RE: 1316 N. Arlington Heights Road- Goddard School Daycare
PC #18-023 Round 2

RE: 1316 N. Arlington Heights Road- Goddard School Daycare
PC #18-023 Round 2

RE: Goddard School
1316 Arlington Height Rd
PC #18023 Round 2
February 18, 2019

FIRE TRUCK TURNING RADIUS PLAN- SOUTH BOUND

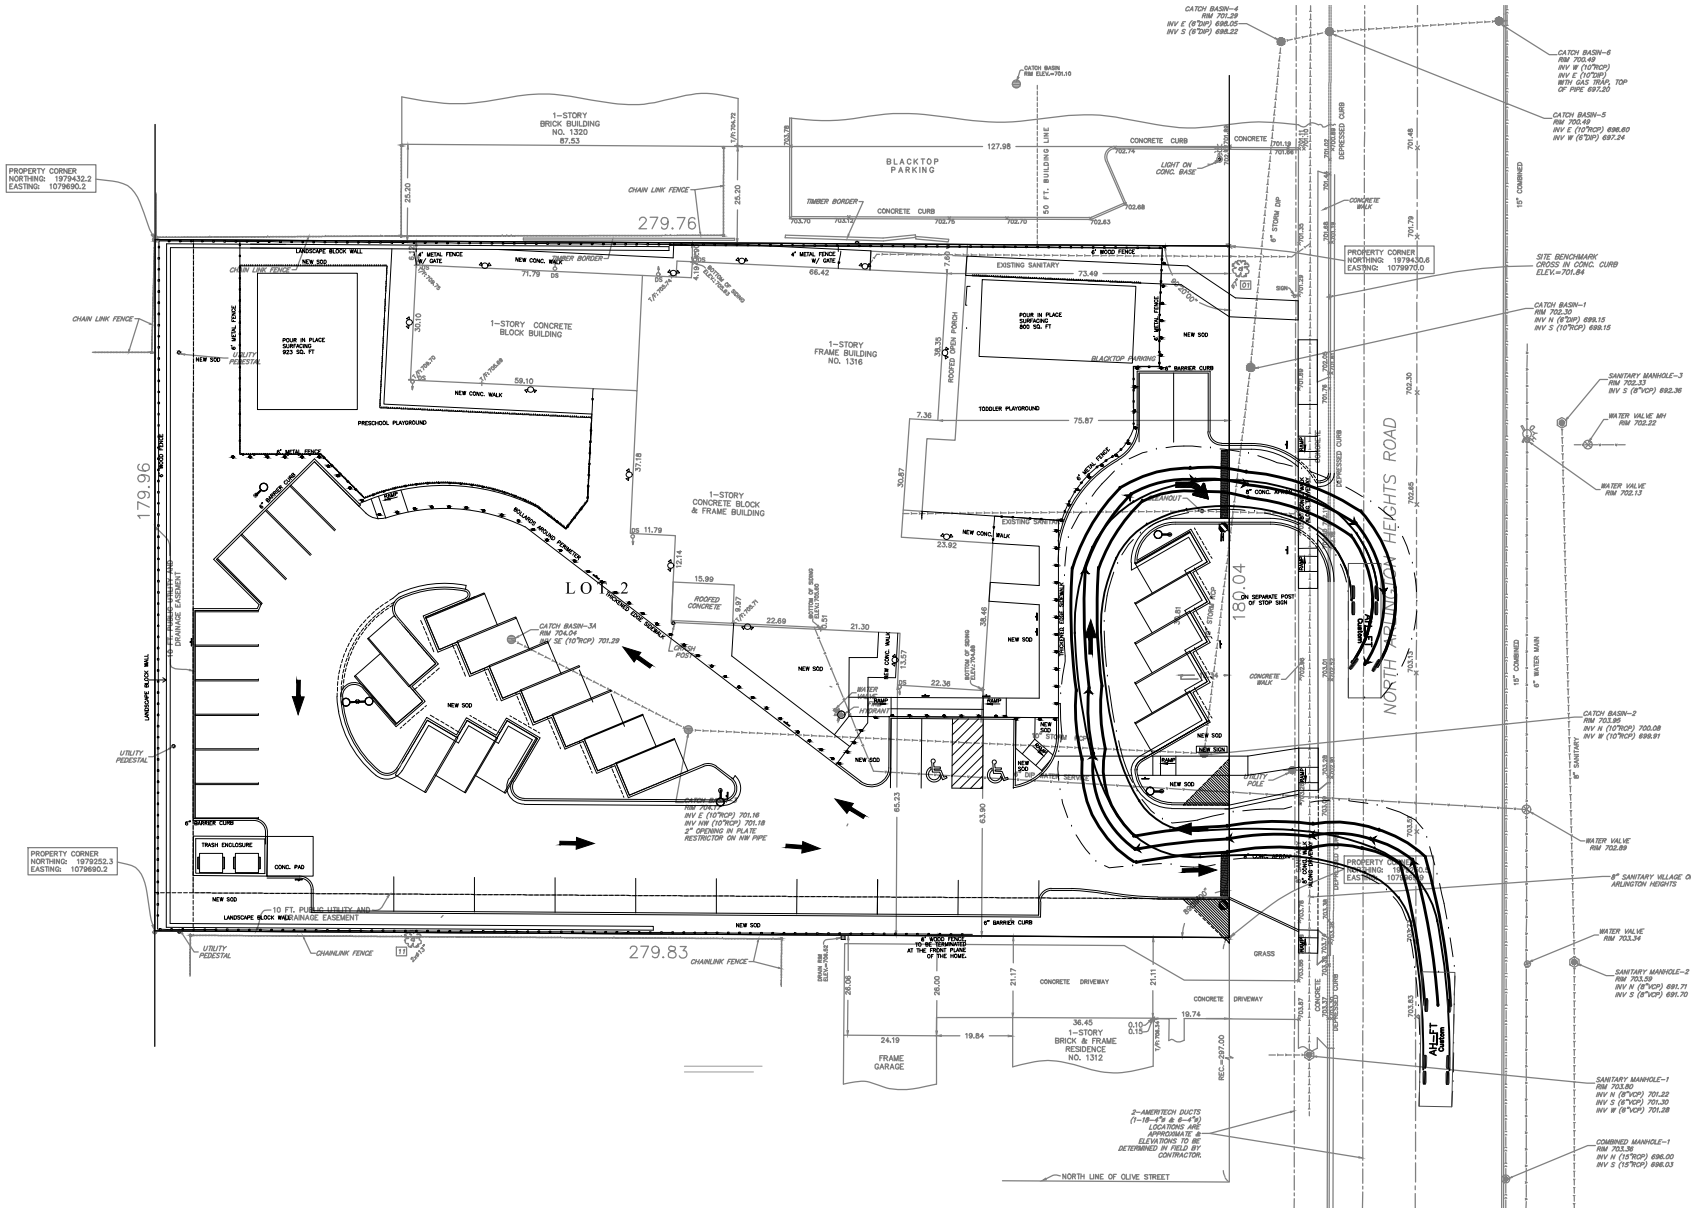
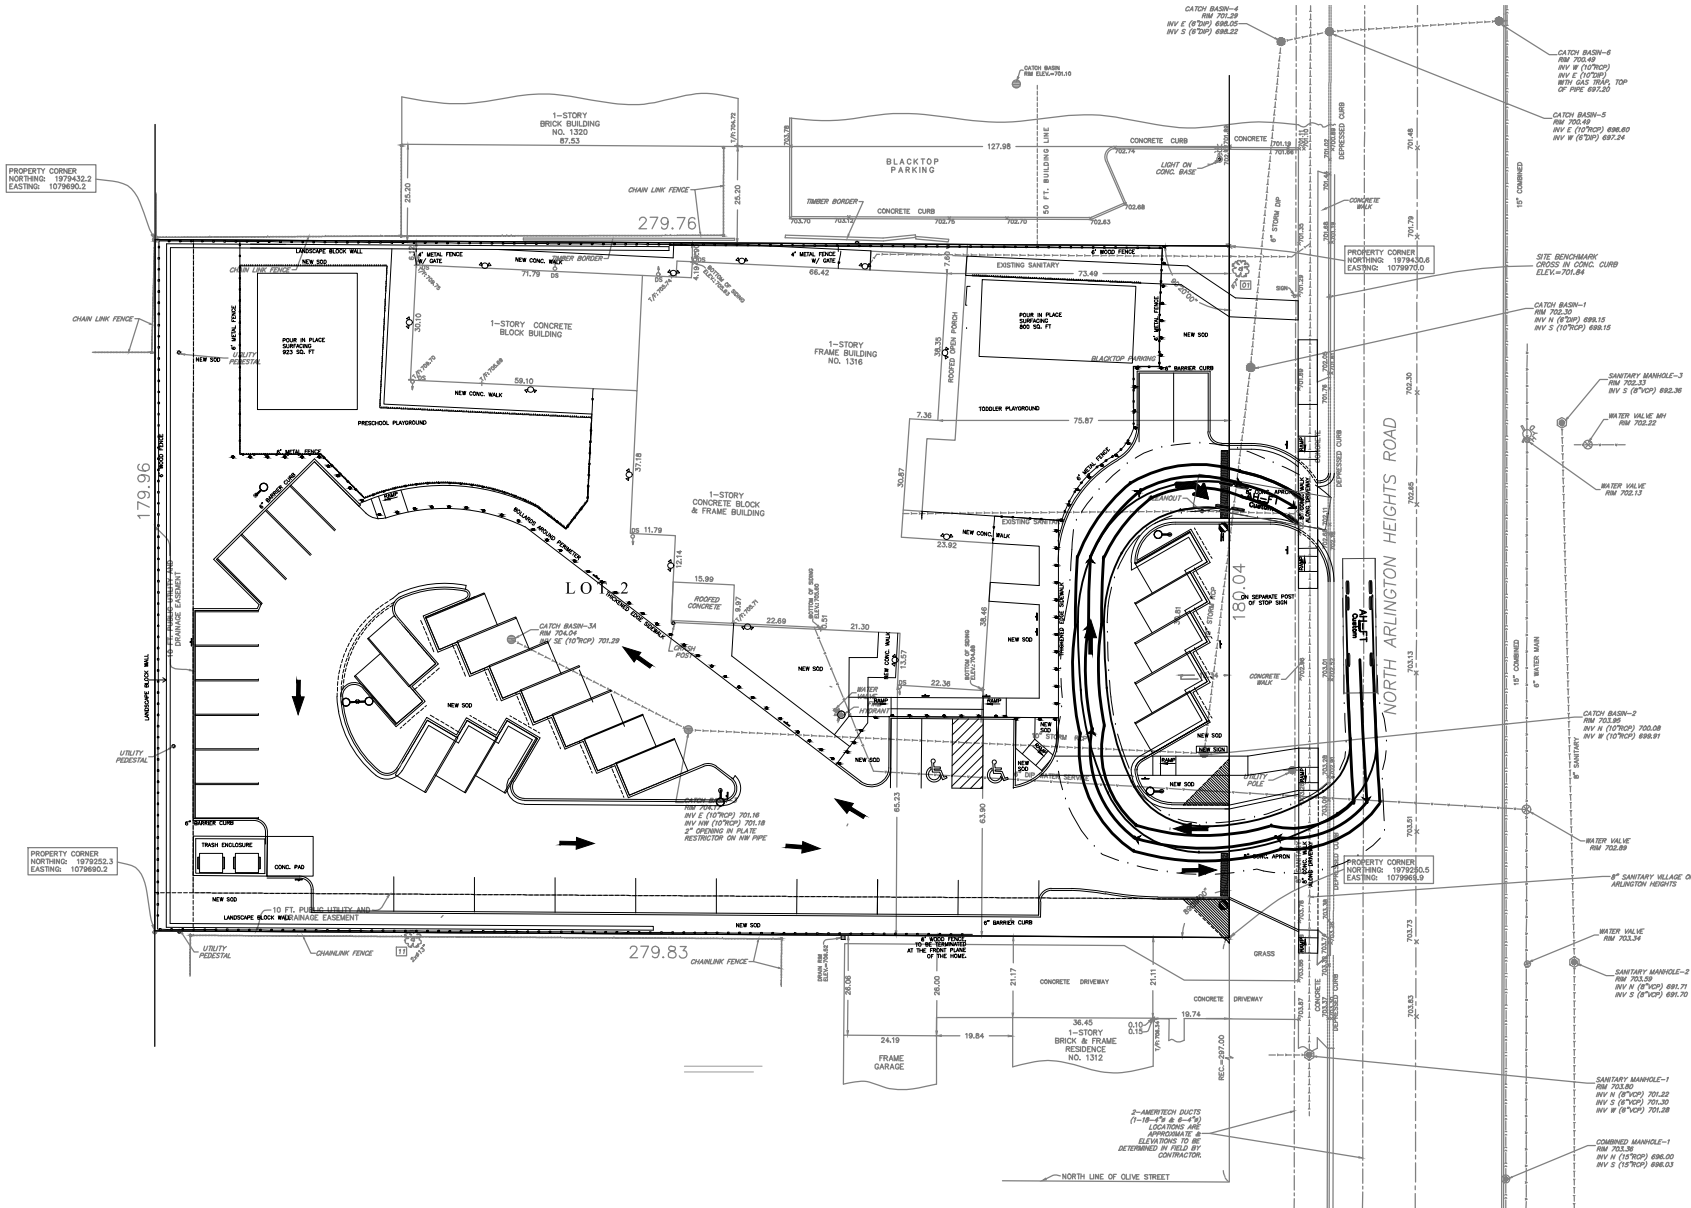
35. This exhibit has been removed from the drawing and is included as an attachment to this letter. The exhibit has been revised so there is no conflict with parking stalls 10 and 11. The fire truck path is shown to enter the right out only exit to allow the firetrucks to access the front of the building. To enter, the firetruck will go over the curb. The curb is necessary to forbid regular traffic from turning left to exit. The right turn only exit has been revised to meet IDOT standards (see response to comment 43). Additionally, an exhibit for the fire truck path of travel from northbound Arlington Heights Road has been provided. This is shown on the Geometric Plan.
